APPLICATION NO.	FILING DATE	FIRST NAMED INVENTOR	ATTORNEY DOCKET NO.	CONFIRMATION NO.
09/681,441	04/05/2001	Peter Fall	VCC0031-US	4762

Office Action Summary

FALL, PETER

FIG. 3

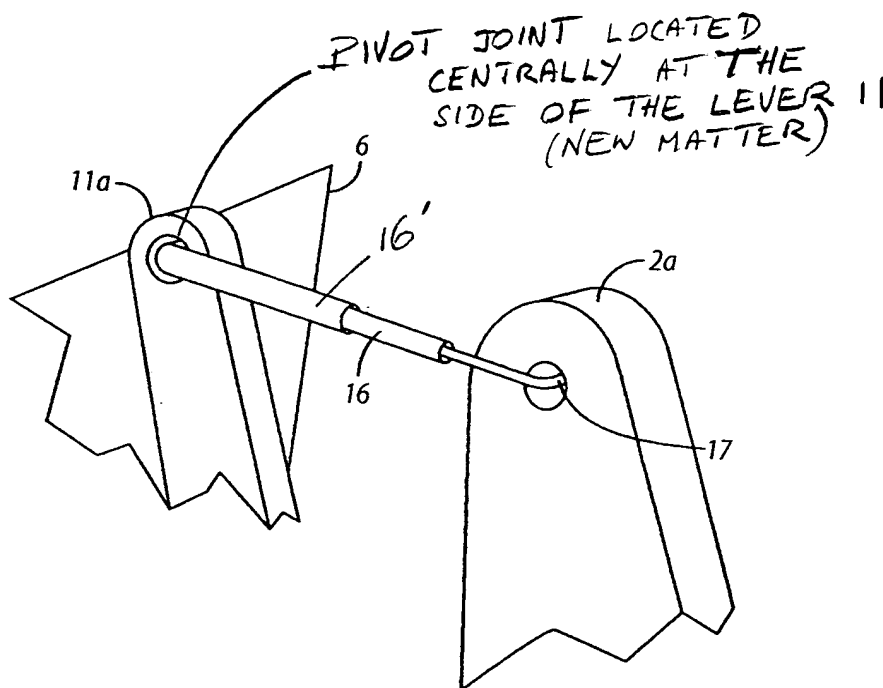
4. The amended drawings were received on December 19, 2003. These drawings are disapproved because new Fig. 3 introduces new matter, such as, (a) the number, size, shape, dimension of the telescopic elements 16 and 16 (see Exhibit I); and (b) the locations of the pivot joints as now shown in Fig. 3.

Although the original specification describes "a rigid telescoping element that is pivotally joined to the respective arms at both ends," however, the original disclosure does not describe, among other things, the following:

- (1) How many elements of which the telescoping element is comprises;
- (2) How the telescopic elements are connected to each other;

(3) The size(s), shape(s), and dimension(s) of the telescopic elements 16 and 16' relative to each other; and

(4) The specific locations of the pivot joints of the telescopic elements 16 and 16' to the pedal arm and the lever.

In other words, the original disclosure implies, e.g., that: (1) the rigid telescoping element may comprise more than two elements 16 and 16' (see Exhibit I) as now shown in new Fig. 3; (2) the shape(s) of a cross section of the telescopic elements 16 and 16' (Exh. I) may be circular, square, or rectangular, etc.; and (3) the telescopic elements 16 and 16' may be pivoted at the side of the lever 11 as now shown in new Fig. 3 or at the front surface of the lever 11 as shown in Figs. 1 and 2. The specific showing of: (a) the number, size, shape, dimension of the telescopic elements; and (b) the locations of the pivot joints within a full spectrum of possible numbers, sizes, shapes, dimensions of the telescopic elements and locations of the pivot joints is considered under the present disclosure to be new matter. *Cf.*, *In re Smith*, 173 USPQ 679 (CCPA 1972) and *Ex parte George*, 230 USPQ 575, 578 (BPAI 1986).

Another example, the concept that the telescoping element is pivoted centrally at the side of the lever 11 as now shown in new Fig. 3 is not conveyed in the original disclosure, *i.e.*, new matter. *In re Anderson*, 176 USPQ 331 (CCPA 1973).

7. The amendment filed December 19, 2003 is objected to under 35 U.S.C. 132 because it introduces new matter into the disclosure. 35 U.S.C. 132 states that no amendment shall introduce new matter into the disclosure of the invention. The added material which is not supported by the original disclosure is as follows: the amendment in the last paragraph of the specification. The original disclosure does not provide support, *inter alia*, for the number of telescopic elements 16 and 16' (Exh. I), size, shape, and dimension of the telescopic elements; and the specific locations of the pivot joint which is at the center of the side of the lever 11 as now shown in new Fig. 3. See explanation of the disapproval of new Fig. 3 above. Applicant is required to cancel the new matter in the reply to this Office Action.

plainly may be illustrated in different ways. Newly submitted Figure 3 does not comport exactly with the descriptions and further does deviate from the teachings of the drawings as already submitted as evidenced by, e.g., the location of the new pivot joint of the telescoping element 16 with the lever 11. The examiner is mindful that if the best mode contemplated by the inventor at the time of filing the application is not disclosed, such defect cannot be cured by submitting an amendment seeking to put into the specification something required to be there when the application was originally filed. *In re Hay*, 189 USPQ 790 (CCPA 1976) cite in MPEP 608.01(h). The examiner respectfully disapproves new Fig. 3 and objects to the amendment to the specification for the reasons set forth in paragraphs 3 and 7 above.

FIG. 1

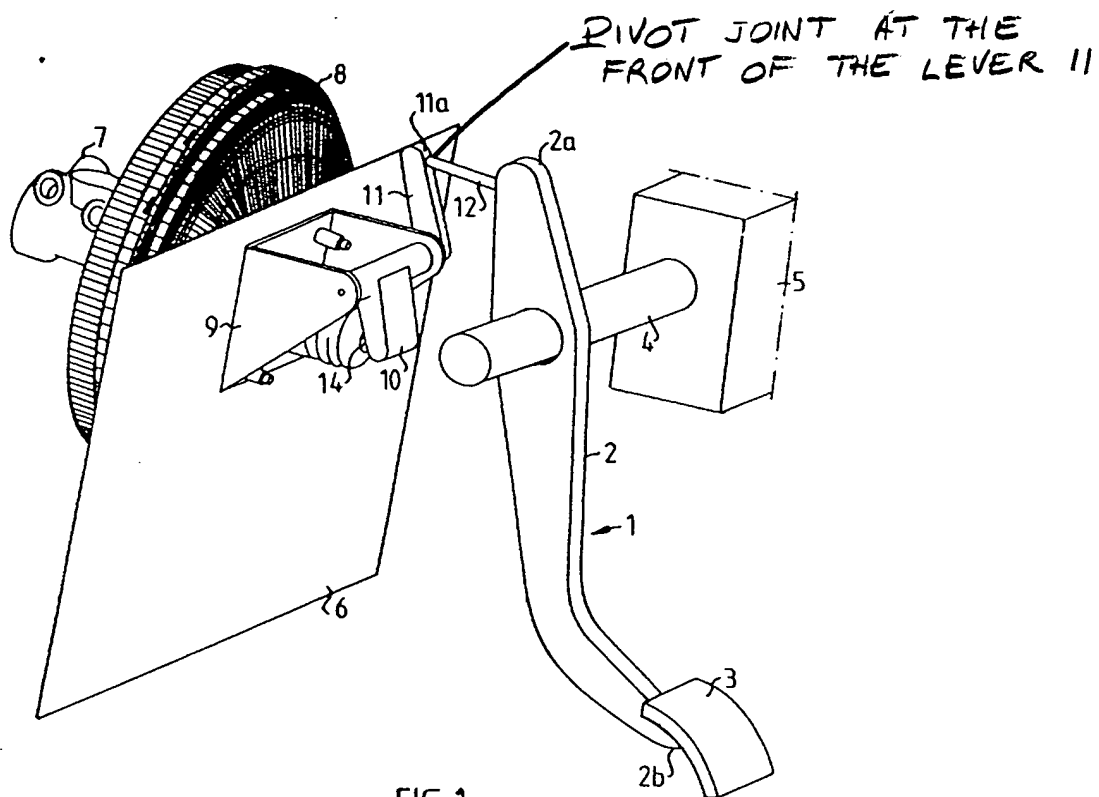
5. The *original* drawings are objected to because each part of the invention, such as, the cab in claims 1, 8, and 18, and the telescoping member in claims 11-13 should be designated by a referential numeral or character. A proposed drawing correction or corrected drawings are required in reply to the Office action to avoid abandonment of the application. The objection to the drawings will not be held in abeyance.

6. The *original* drawings are objected to under 37 CFR 1.83(a). The drawings must show every feature of the invention specified in the claims. Therefore, the claimed features such as the

cab in claims 1, 8, and 18; and the telescoping member in claims 11-13 must be shown or the features canceled from the claims. No new matter should be entered.

Applicant's drawings do not show the cab. See, e.g., the cab 1 in Fig. 1 of US Patent No. 6,082,219 issued to Wolpert.

Bayer teaches applicant's embodiment in Fig. 1. Applicant explicitly admits that applicant's embodiment of Fig. 1 and applicant's embodiment of Fig. 2 are not patentably distinct in Paper No. 10. In addition, claims 13 and 15 are drawn to applicant's embodiment of Fig. 1.

EXHIBIT II

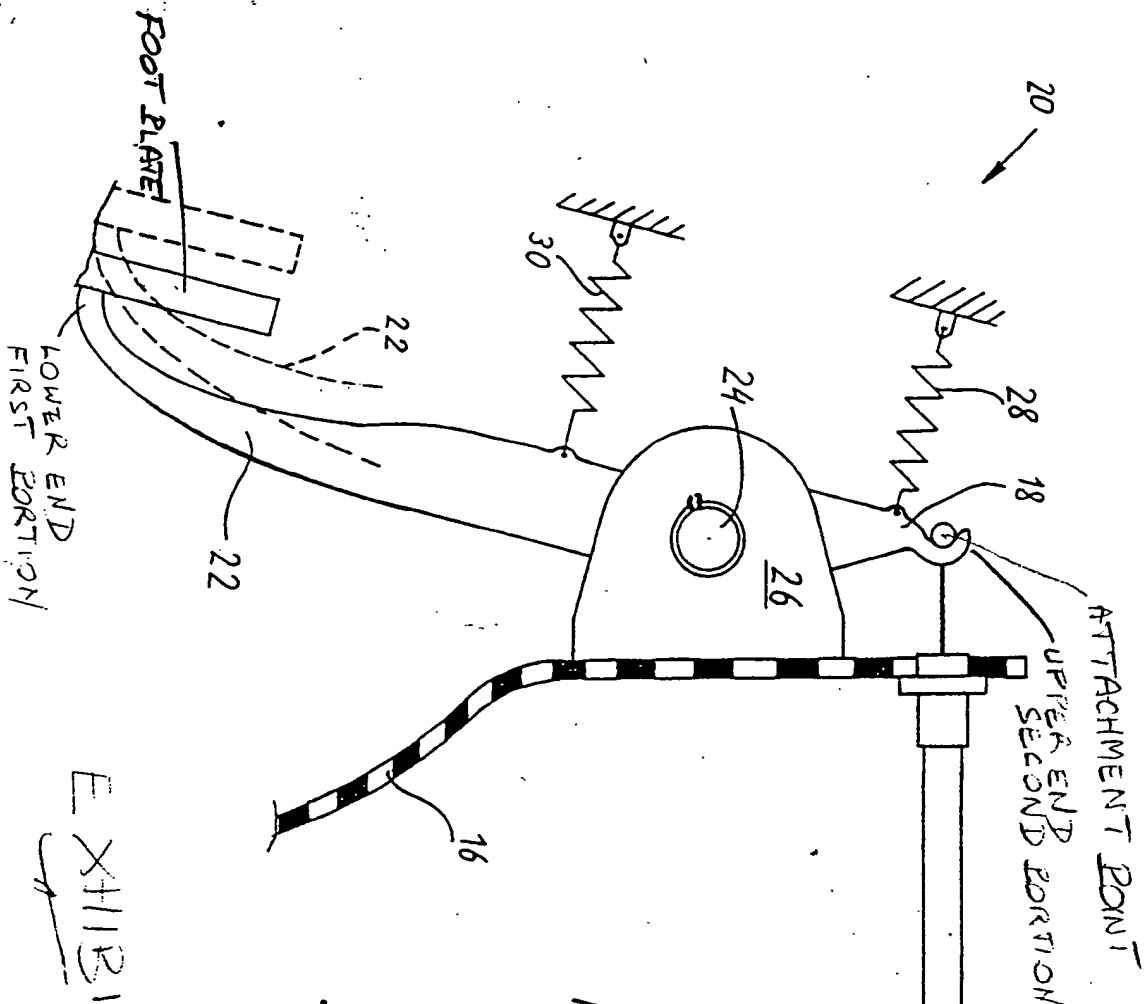
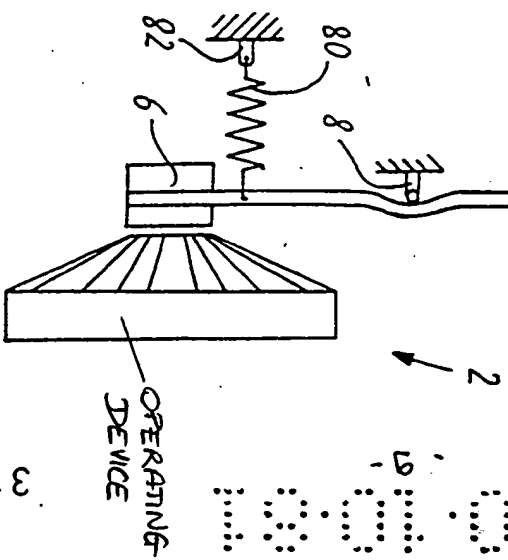
a support 26 fixed in the cab (Fig. 2);

at least one pedal arm 22 having two ends (at 18 and 22 in Fig. 1), wherein the pedal arm 22 is journaled in the support 26 for pivoting about a pivot axis 24 spaced between the two ends of the pedal arm 22;

a foot plate (unnumbered, see Exhibit II) fixed to a first portion (at 22 in Fig. 1) of the pedal arm 22 on one side of the pivot axis;

a motion-transmitting element 10 inherently disposed wholly within the cab, wherein the motion-transmitting element 10 is joined firstly to a second portion 18 of the pedal arm 22 on the other side of the pivot axis 24 from the foot plate and wherein the motion-transmitting element 10 is joined secondly to a pivotally mounted lever 4 that is configured so that pivotation thereof actuates an operating device 2; and

wherein the motion-transmitting element 10 is disposed so that the distance between the motion-transmitting element's respective attachment points (Exh. II) to the pedal arm 22 and the lever 4 is maintained at least substantially constant when there is a tensile force on the element 10 (i.e., when the foot plate is moved downwardly as shown by solid line position in Fig. 1) and is allowed to be mom-fixedly shortened when there is compressive force on the

element 10 (i.e., when the foot plate is moved upwardly as shown in dashed line position in Fig. 1); and

wherein the motion-transmitting element 10 is rigidly fixed to at least one of the pedal arm 22 and the lever 4, and is pivotally joined to the other of the pedal arm 22 and the lever 4.

a brake pedal arm 22 pivotally connected to the vehicle at a pivot point 24 located on the brake pedal arm 22, the pivot point 24 being positioned between an upper end 18 and a lower end (at 22 in Fig. 1) of the brake pedal arm 22; and

a motion-transmitting element 10 inherently disposed wholly within the cab and being connected between the brake pedal arm 22 and a pedal actuated operating device 4, 2, the motion-transmitting element 10 supporting tensile forces imposed thereupon (i.e., when the foot plate is moved downwardly as shown by solid line position in Fig. 1), and non-fixedly collapsing under compressive forces imposed thereupon (i.e., when the foot plate is moved upwardly as shown in dashed line position in Fig. 1).

Regarding claim 11, the motion-transmitting element 10 comprises a telescoping member since the element 10 is slid back and forth (telescope) within another element, i.e., a conduit 12.
